SAFETY RECALL BULLETIN

SUBJECT: DRIVE BELT AUTO TENSIONER – SAFETY RECALL CAMPAIGN			No: SR-18-001
			DATE: March 2018
			MODEL: See Below
CIRCULATE TO:	<input checked="" type="checkbox"/> GENERAL MANAGER	<input checked="" type="checkbox"/> PARTS MANAGER	<input checked="" type="checkbox"/> TECHNICIAN
<input checked="" type="checkbox"/> SERVICE ADVISOR	<input checked="" type="checkbox"/> SERVICE MANAGER	<input checked="" type="checkbox"/> WARRANTY PROCESSOR	<input checked="" type="checkbox"/> SALES MANAGER

This campaign bulletin instructs dealers to inspect and, if necessary, replace the drive belt auto tensioner with a countermeasure part.

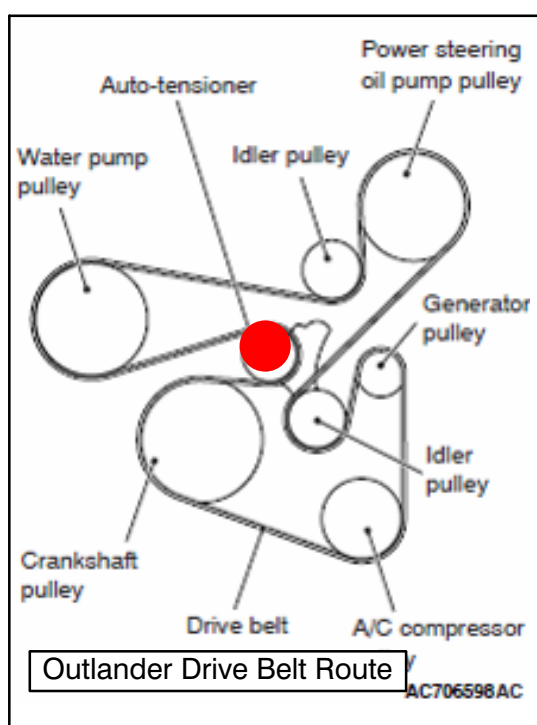
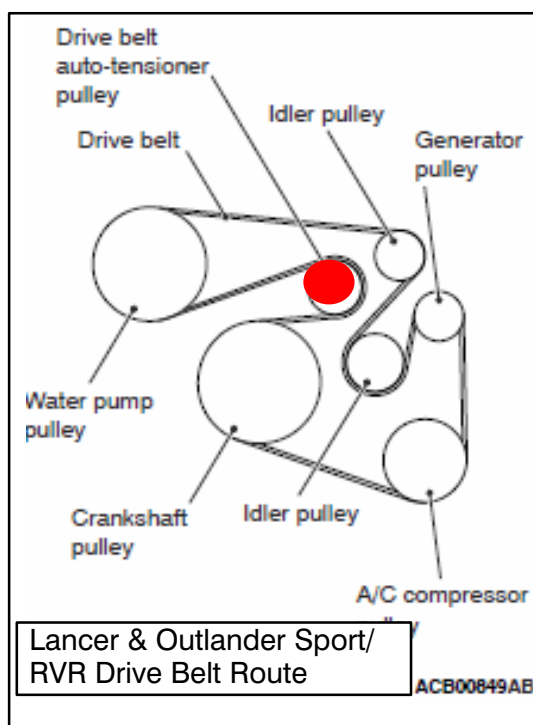
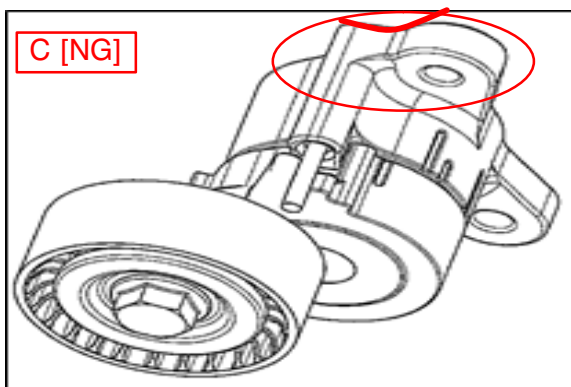
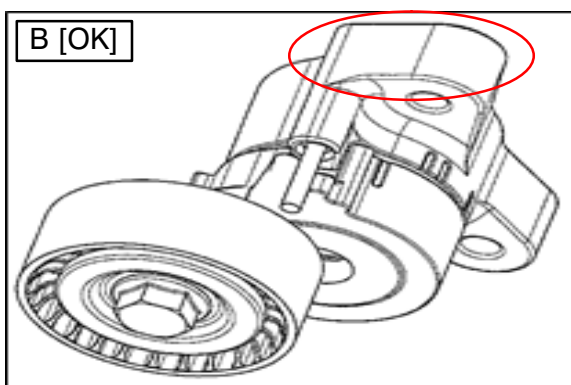
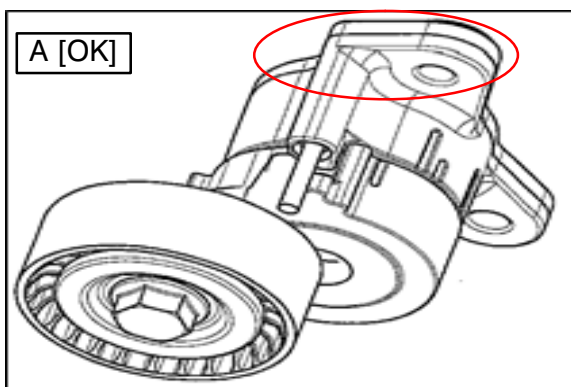
2. Inspect the auto tensioner flange with a mirror and a flashlight to check whether the flange is before (concave type flange) or after (straight type flange) the countermeasure.

NOTE: It may be easier to check if you move a mirror closer to the auto tensioner along the drive belt

- a. Placing the mirror closer to the auto tensioner along the drive belt.

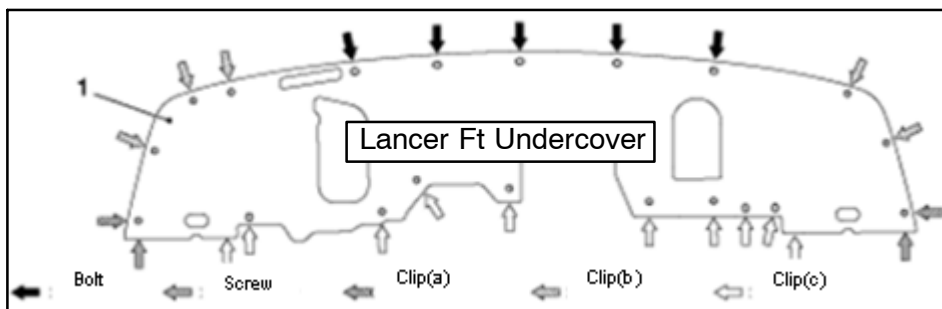
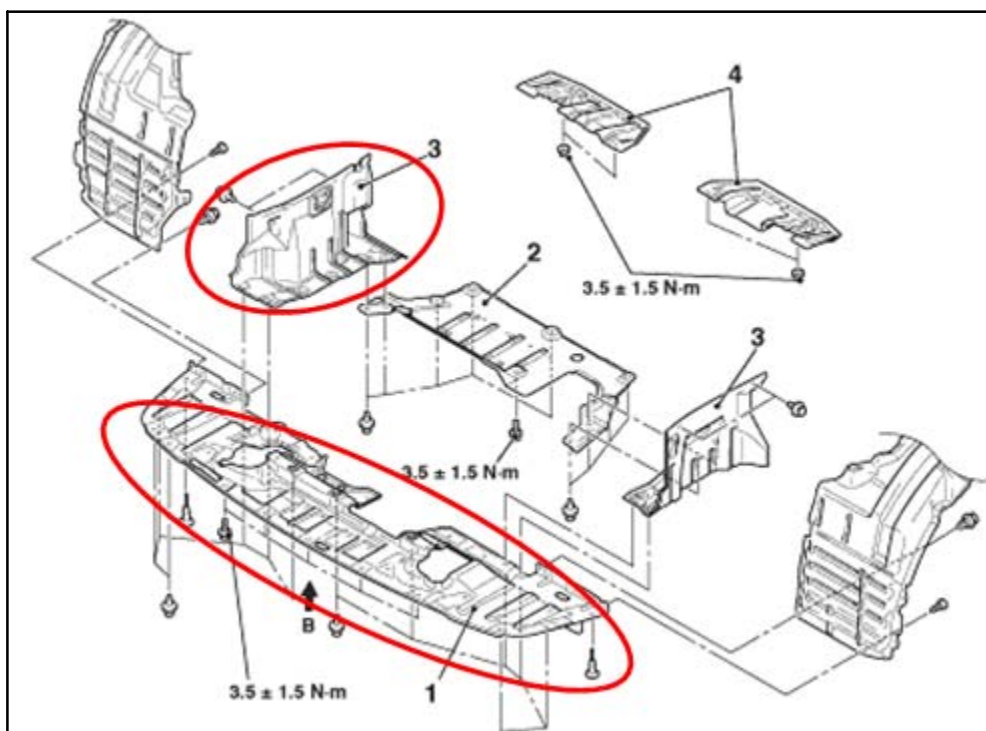
3. Check the auto tensioner and note the flange shape.
 - a. If the flange is straight, as illustrated in figures A and B, **leave as is** and go to **step 4**.
 - b. If the flange is concave, as illustrated in figure C, proceed to **Auto Tensioner Removal** process.
